STATE OF OREGON
DEPARTMENT OF ENVIRONMENTAL QUALITY

PERMIT NO. 94-119

TO: Crestview-Greenwood Cemetery
T8N, R9W, S34, TL1800
Construction Permit # 94-119

SUBJECT: Pre-cover inspection

Dewey Darold
8-4-94/8-29-94
As-built/Pre-cover Ins.
(NTS)

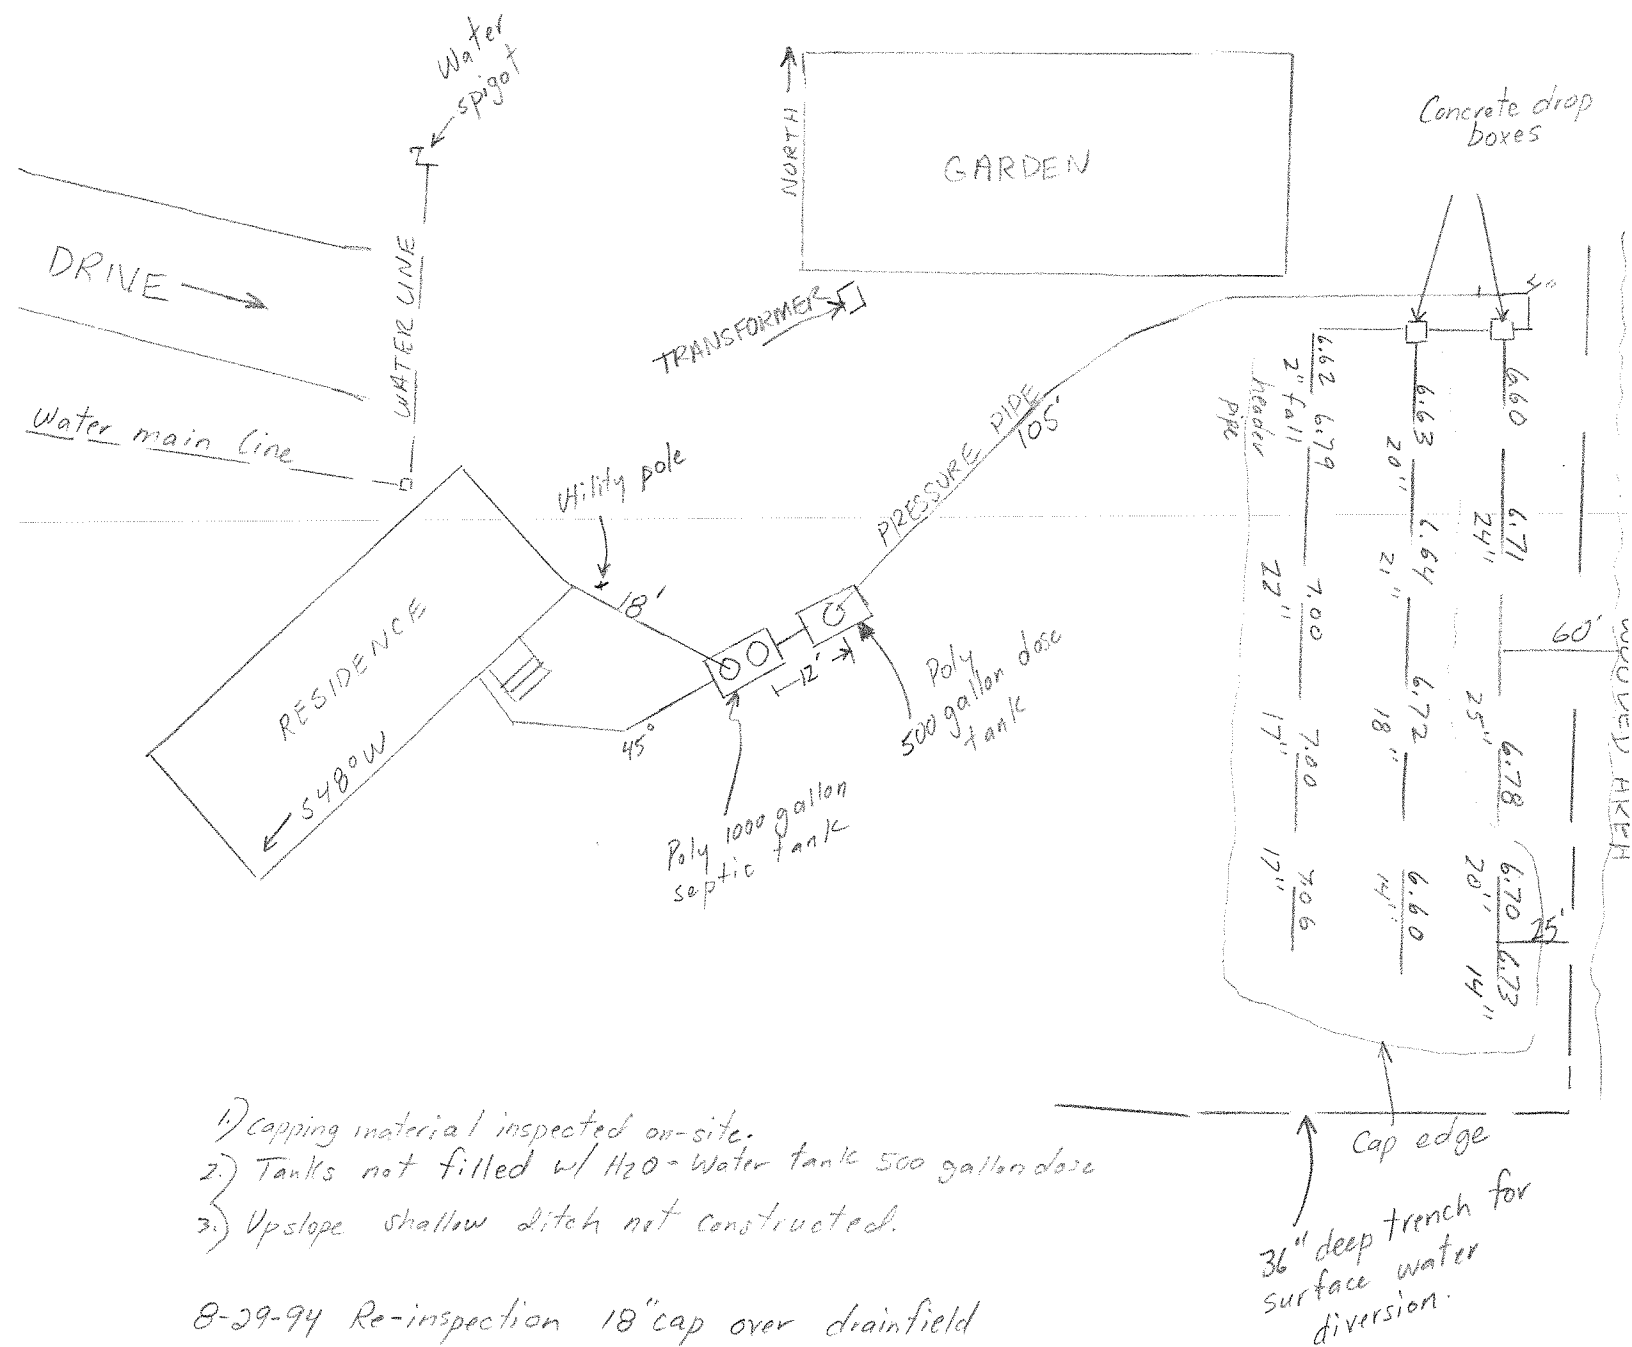
In reference to the August 4, 1994, pre-cover inspection, Mr. Lemay indicated that he used a hand level to lay the pipe in the trench. Also, Mike indicated that he used a ditch witch to excavate for the disposal trenches and used a spade shovel to widen the disposal trenches to two feet.

On August 5, 1994 another inspection was conducted. The pipe was laid level plus or minus one inch. Mike has rented a transit. All other corrections noted on the August 4, 1994 inspection were made. I gave Mike's son a copy of the partial as-built plot plan. Next step is to place cap over drainfield. Showed Mike the area of the drainfield to cap and how much. The capping material used will be from on-site. Mike showed me some soil which he intends to use for the cap. The soil was inspected and found to be acceptable. Told Mike to make sure any large roots or clods be removed before cap is placed over drainfield. Told Mike that he may need more capping material than what is on-site.

August 5, 1994 reinspection: Concrete drop boxes from Ed Fisher. Dose tank purchased from Ed Fisher. Dose tank says for water use only. Header pipes not level from header pipe outlet. Poly septic tank full of water. Outlet end of septic tank slightly lower than inlet side. Float controls on separate assembly. Mentioned to grout Inlet and outlet ports at drop boxes and alarm protected from weather.

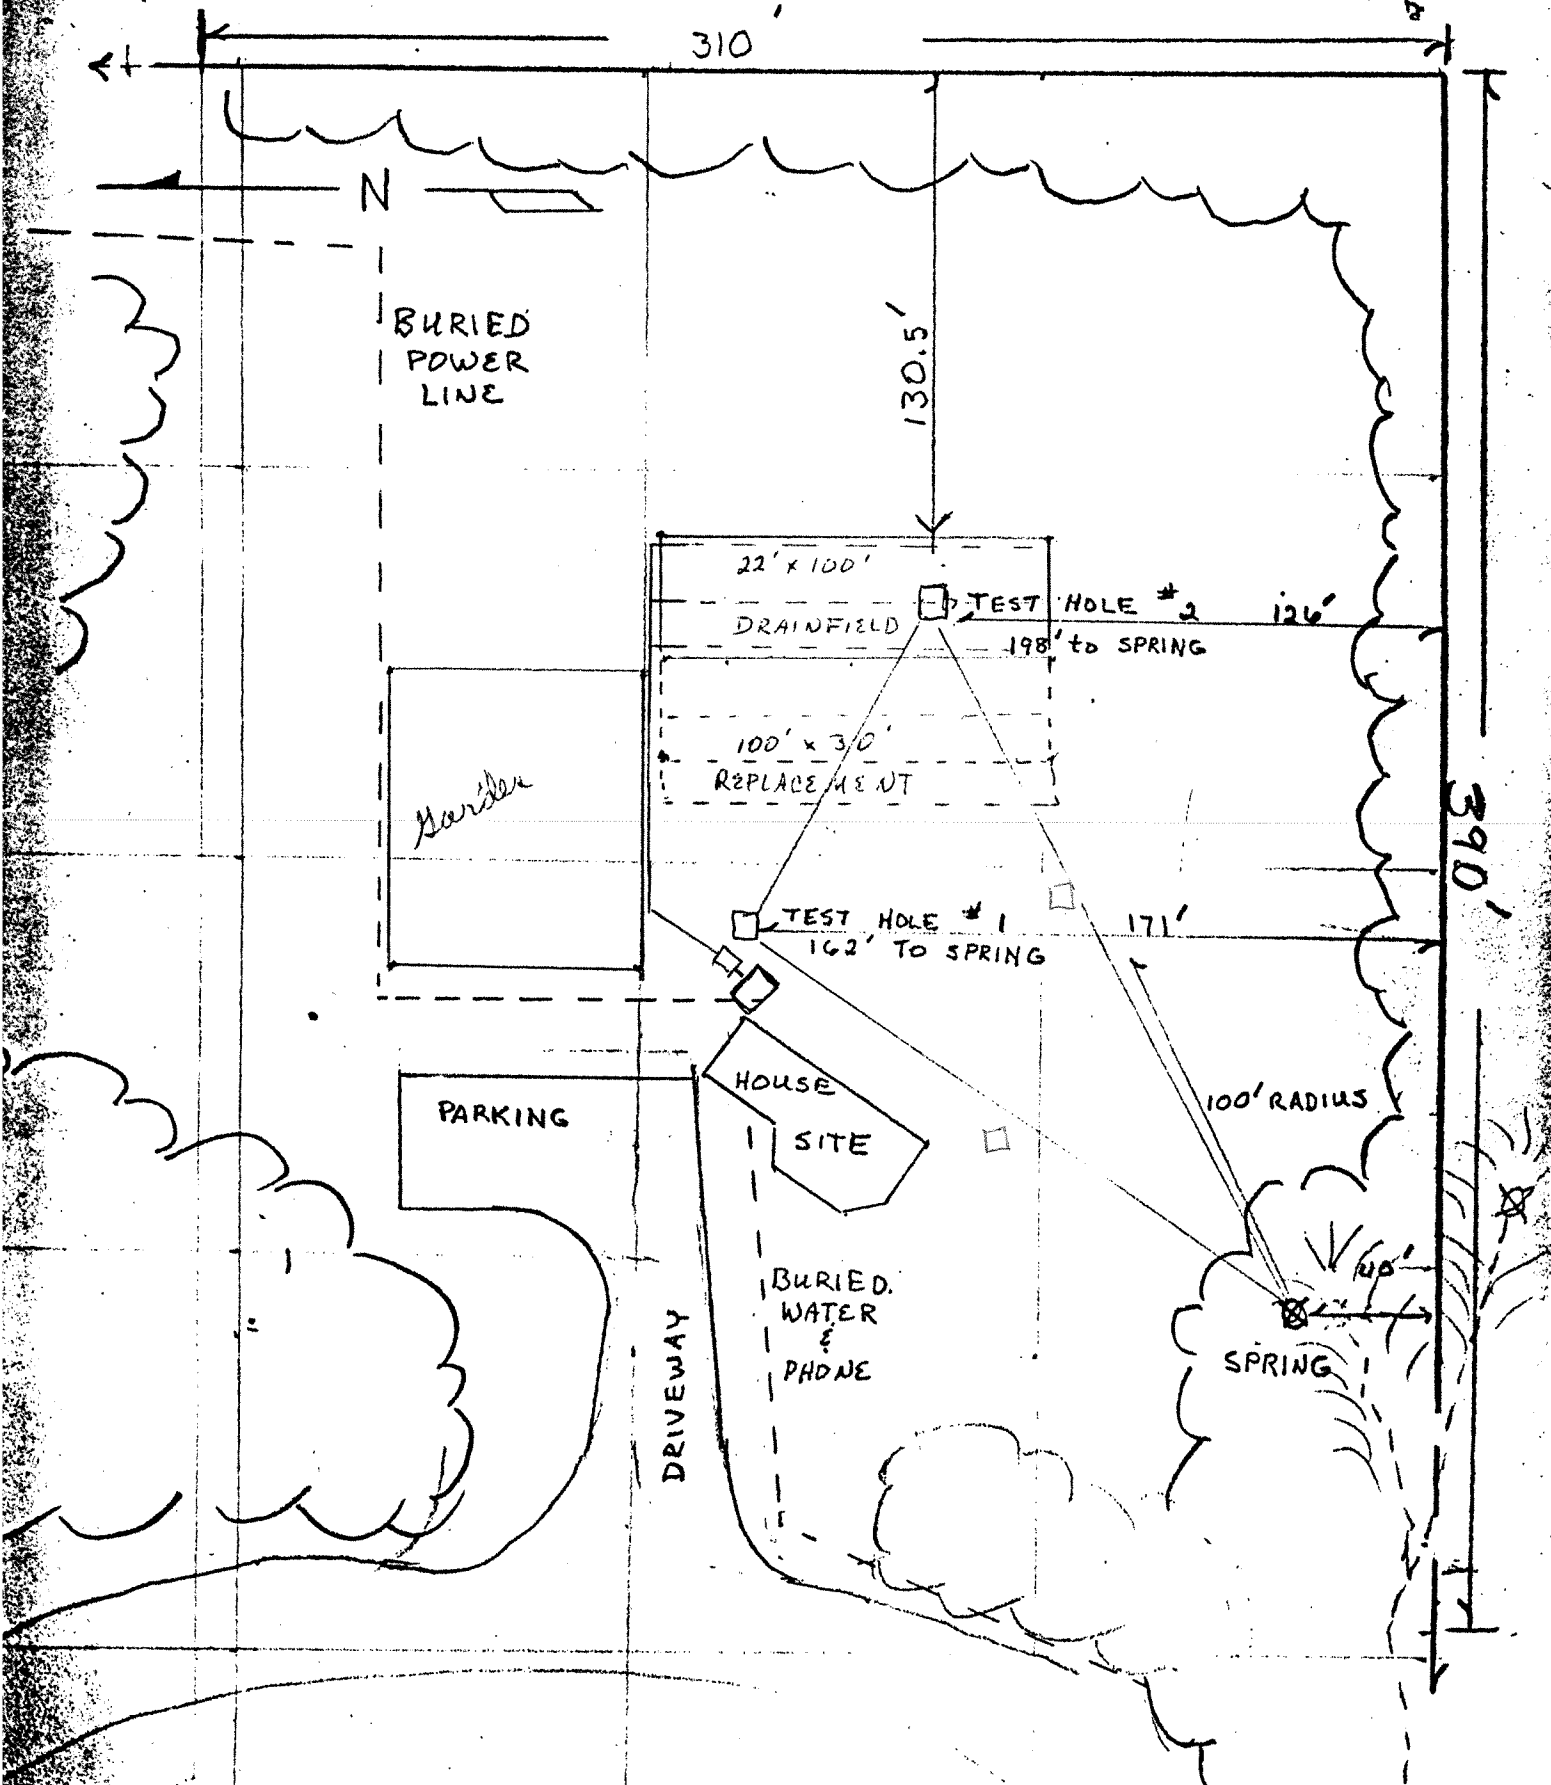
Our office has received a plot plan for a permit to construct an on-site sewage disposal system on the above described property. Additional information is requested in the form of a revised plot plan. Please address the following.

- 1) Indicate the manufacturer of the septic tank.
- 2) Specify the type of filter fabric to be used over the top of the filter material. Also, indicate type and source of filter material (drainrock) to be used in the construction.
- 3) Indicate manufacturer of drop boxes and type of perforated pipe to be used. Show a 4' solid header pipe between the drop box and the perforated pipe.
- 4) Show the test pits on the plot plan and a 50 foot setback to the drainage swale.

Given the location of the house and the distance to the approved area for the drainfield, which is slightly upslope, it is unknown whether gravity flow can be achieved. The trench depth can not exceed 24 inches and must be installed a minimum 12 inches into the natural soil. Therefore, we request that you provide us with the following elevations.

- 1) Ground surface elevations at the beginning and ends of the disposal field and at the septic tank.
- 2) Top of pipe elevations at the septic tank inlet and outlet connections and the perforated pipe in the drainfield.

TRANSFORMER
 BURIED POWER LINE
 PVC 3034 2" fall
 INDEX ELEV AT GROUND LEVEL
 500 gal SURGE TANK (NORWEST) with GOULD EFFLUENT LIFT PUMP 1/2 HORSE POWER
 1000 GAL NORWEST POLY SEPTIC TANK
 Follow mfg. recommendation for tank installations. Fill w/ H₂O
 6' setback to home before backfilling
 Home site
 SPEC'S :
 DRAINFIELD CAPPED TO 12" COVER WITH EXTRA SOIL FROM TRENCHES PLUS Adjacent soil as needed for grade.
 TRENCHES: 2' wide, 24" maximum depth.
 DRAIN ROCK (JOHNSONS - Seaside): 6" under pipe, 2" over, total of 12"
 Fabric by TYPAR
